# SAFETY RECALL NOTICE

Subject <b><u>Aftermarket Steering damper kits</u></b>	Report number 131119-SD	Date 2013-11-19	Page 1(3)
Author Göran Hedin	Distribution Distributors

## **Aftermarket Steering damper kits**

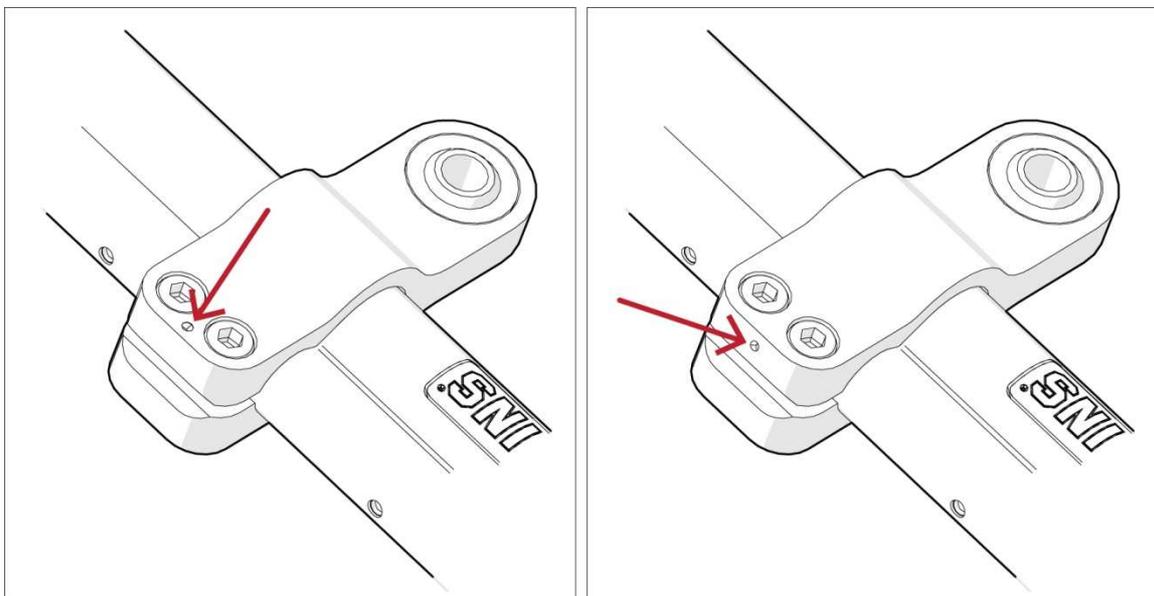
Öhlins Racing AB have discovered a safety issue with the risk of cracks occurring in the bracket for the Aftermarket steering dampers kits listed in on page 3. This is in addition to the previous recall notice for BMW steering damper kits SD 033, SD 037 and SD 038 from June 2013.

The cause is material being machined in an unfavorable direction in combination with probable material defect and the aluminum alloy being sensitive for stress corrosion cracking.

This is valid for all steering damper kits listed on page 3 produced from September 2008 until October 2013. This material has now been replaced and the issue does not exist on steering dampers produced today. Seven known cases have been discovered so far and as a result of this we have decided to recall all sold steering dampers of these batches. There is a risk if the bracket will fail, that the bracket can slide on the cylinder body resulting in less steering angle in one direction or possibly a sensation of uneven or asymmetric damping. Either of these events may surprise the rider in a way that the rider does not have full control of the motorcycle.

The batch numbers for the steering dampers with this safety issue is listed on page 3. New brackets will be manufactured and sent out to you for replacement with a preliminary starting date in November. The replacement bracket will be easy to identify with a small dot either between the two small clamp screws on top or at the edge of the bracket.
